ENGINEER CHANGE NOTICE	ECN NO.
		10010401
		Issue Date
		Jan 04, 2010

Title	BL12864G metal frame change	Part number	BL12864G series
		Customer	
Reason	☐ Request by customer ☐ Quality improvement ☐ Cost reduction ☒ Productivity improvement ☐ Other materials supply issue

Before change	After change
Drawing		Add 4 indents to fix panel position indent size: 3L*1W*1.5D mm  Ladder shape to fix panel securely

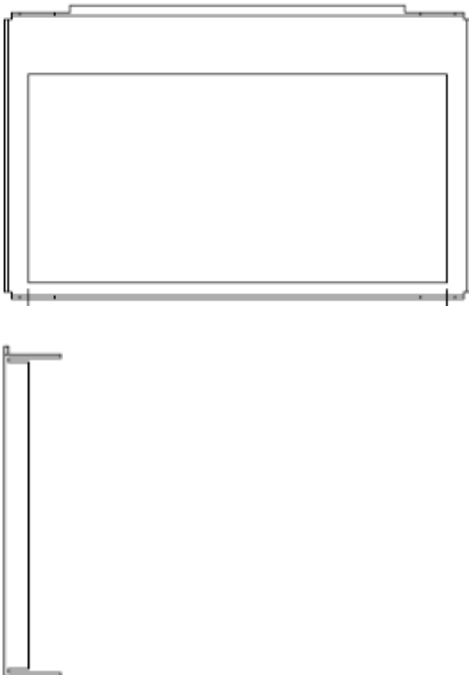
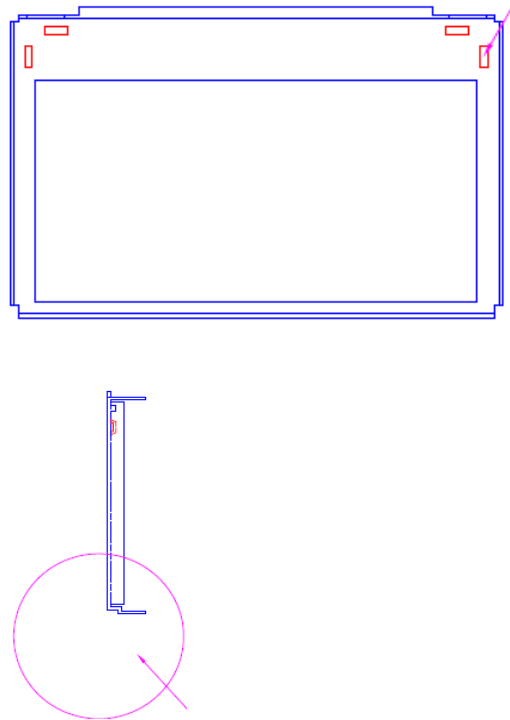
In order to improve the production process and panel displacement issue. We would modify the design of frame and rubber as follows:

1. Add four indents to fix panel position. Indent size: 3L*1W*1.5D (mm)
2. Ladder design on the sides of frame to fix the panel more securely.
3. Change rubber size to fit the new frame.

The electronic specification doesn't change, just frame appearance different.
